# DART SERVICE INSTRUCTION

TO AMEND INSTALLATION INSTRUCTIONS IIN-D058-676 REV. A AND  
INSTRUCTIONS FOR CONTINUED AIRWORTHINESS ICA-D058-676 REV. 0  
REF: FAA STC: SR01018SE

# ENGINEERING CHANGE NOTICE

**Reason for Change:**  
Use Magnobond 6398 on crosstube supports. DSI 9425 indicates the change to the customer.

**FIGURE 1 - CROSSTUBE SUPPORT**

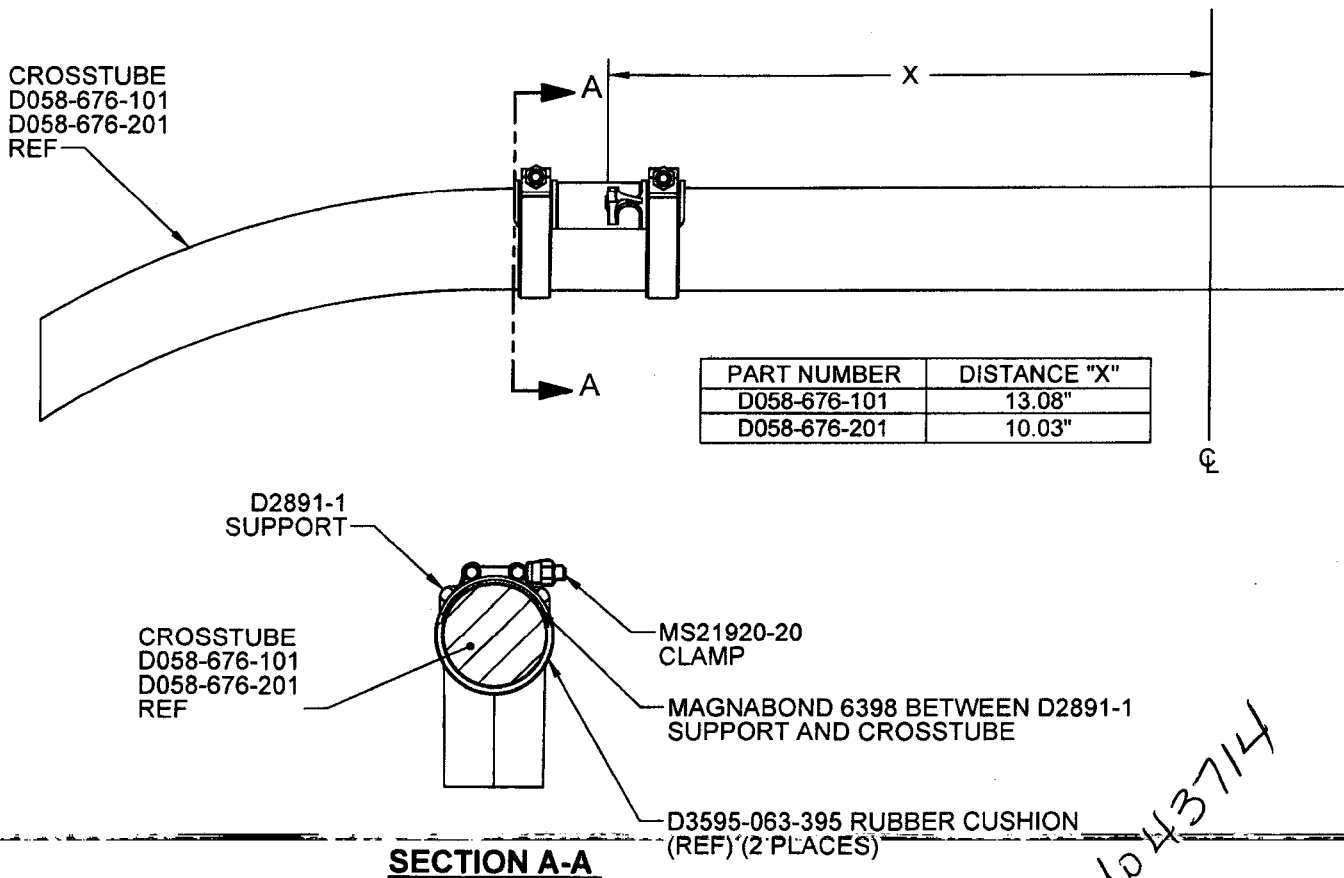
For D058-676-101/-201 crosstubes at CHG 002 or later, the D2856-400-694 abrasion strips have been removed, the D2891-1 supports have been bonded onto the crosstube using Magnabond 6398 and D3595-063-395 Rubber Cushions have been installed underneath the MS21920-20 Clamps. Amend parts list of the IIN-D058-676 Section 5 and ICA-D058-676 Section 32.8 as follows:

To prevent the supports from shifting on the D058-676-101/-201 crosstubes at CHG 001, the D2891-1 supports should be removed and re-installed as follows:

- 6) Apply a 0.03" to 0.06" thick layer of Magnabond 6398 underneath each D2891-1 support and re-install the support on the crosstube as shown in Figure 1. Position and secure the D2891-1 supports on the crosstube using MS21920-20 Clamps. Install a D3595-063-395 Rubber cushion underneath each MS21920-20 Clamp. Torque clamps 80-100 in-lb. Let the D058-676-101/-201 crosstube assembly cure as per the Magnabond 6398 instructions before re-installing the crosstube on the aircraft.
